Templeogue / Rathfarnham to City Centre Core Bus Corridor Scheme

NTA Observations on the Proposed Scheme Submissions

December 2023

Figure 2.2.6 Extract from General Arrangement Drawings (Sheet 35)

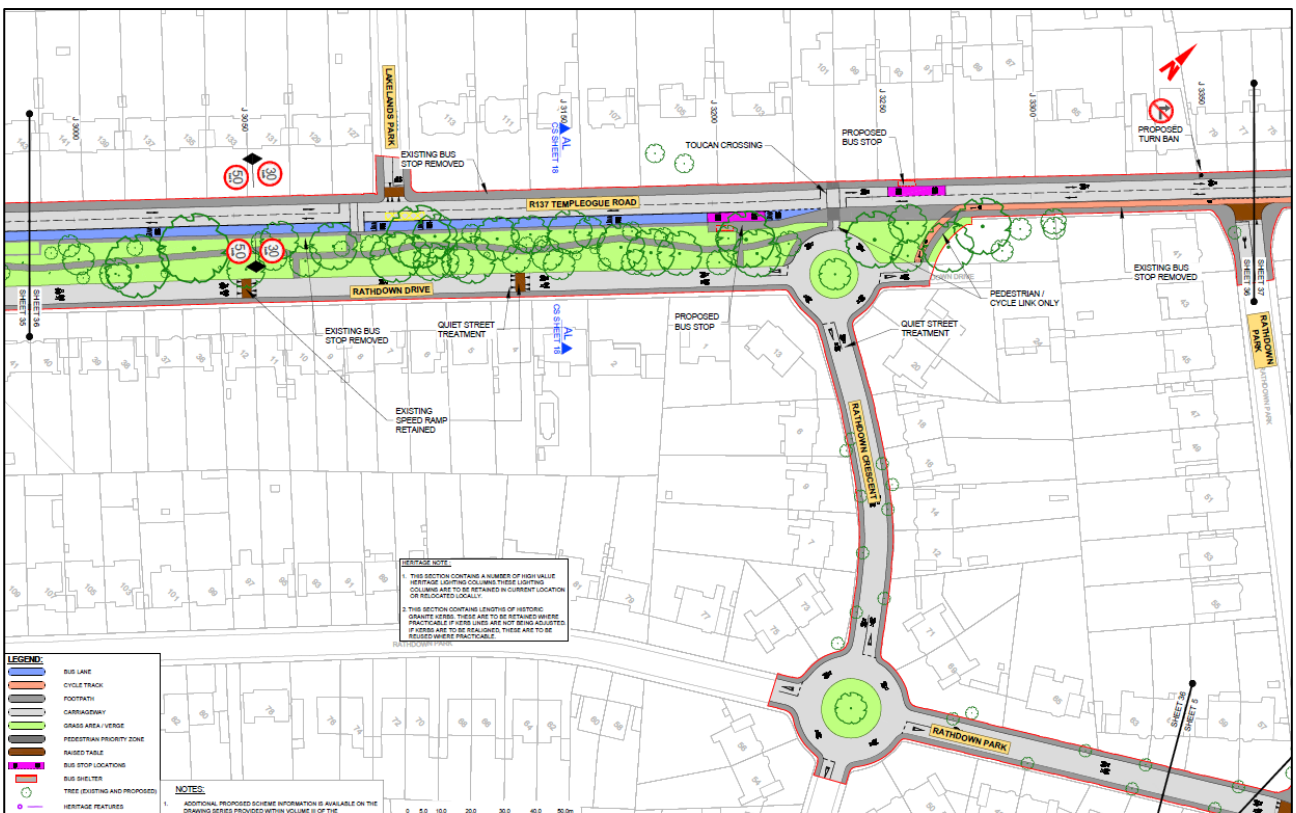
Figure 2.2.1 to Figure 2.2.9 present extracts from General Arrangement Drawings from Figures: Part 1 of 3 of Volume 3 of the EIAR showing Proposed Scheme layout along Templeogue Road.

Figure 2.2.10 Flow Difference on Road Links (Do Minimum vs. Do Something), AM Peak Hour, 2028 Opening Year (Diagram 6.40 from Chapter 6 of the EIAR)

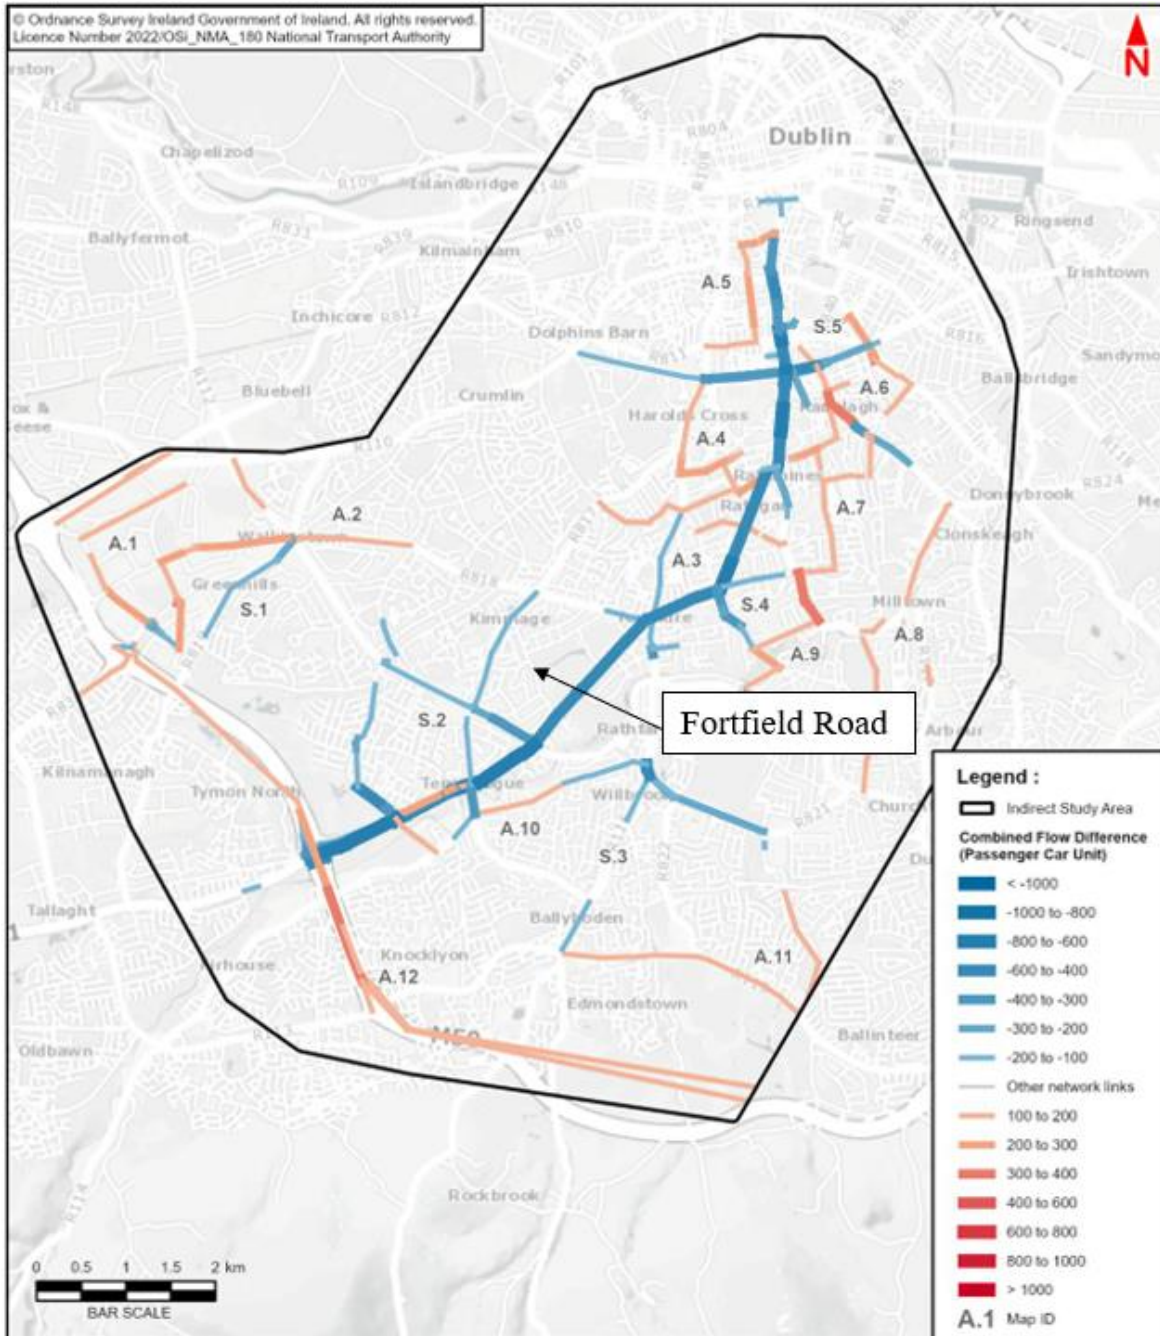
Section 6.4.6.1.15 of Chapter 6 of Volume 2 of the EIAR presents the results of the traffic assessment undertaken. Diagram 6.40 and 6.41 illustrates the flow difference (Do Minimum vs. Do Something) on road links in the study area during the 2028 AM and PM peak hours respectively. These diagrams are reproduced below.

Figure 2.4.6 Extract from General Arrangement Drawings (Sheet 11)

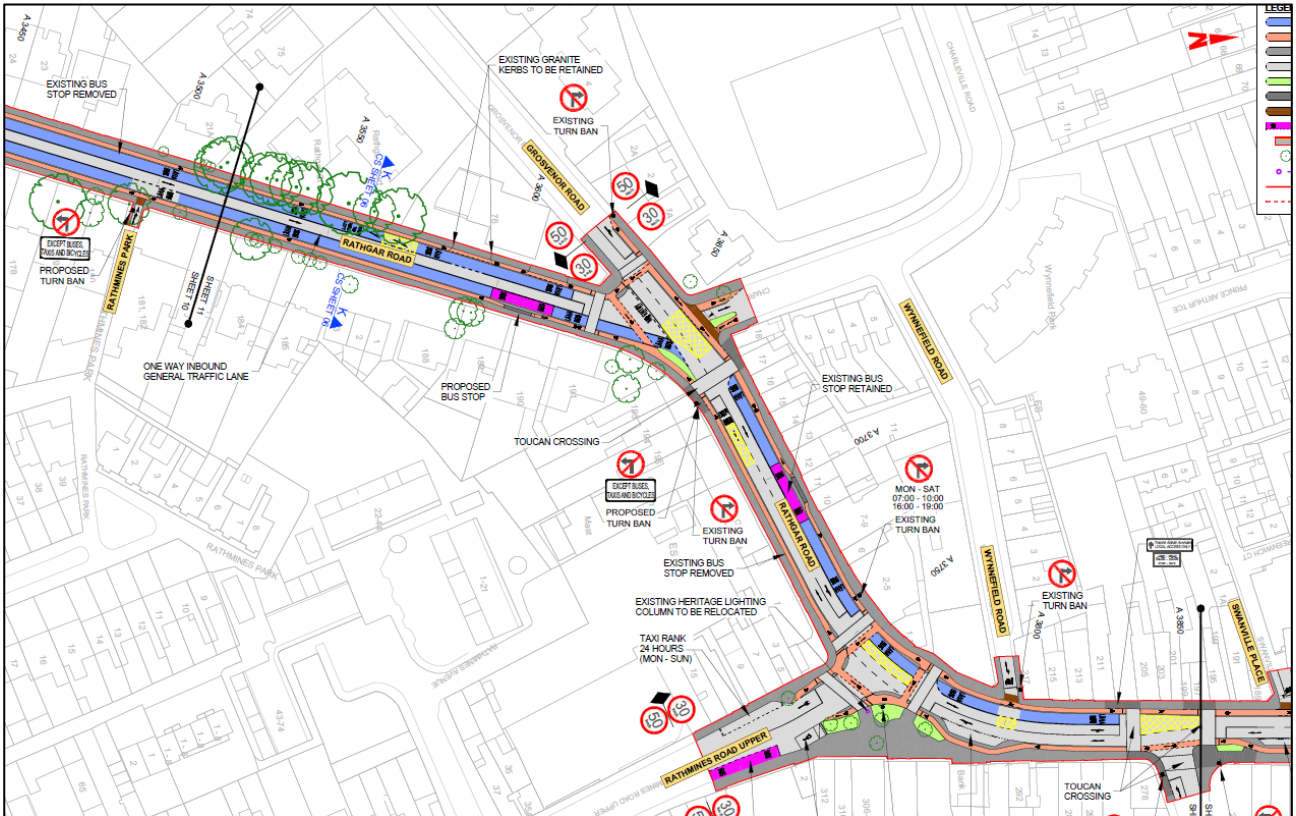
Figure 2.4.1 to Figure 2.4.6 present extracts from General Arrangement Drawings from Figures: Part 1 of 3 of Volume 3 of the EIA showing Proposed Scheme layout between Terenure and Rathmines along Terenure Road East and Rathgar Road.
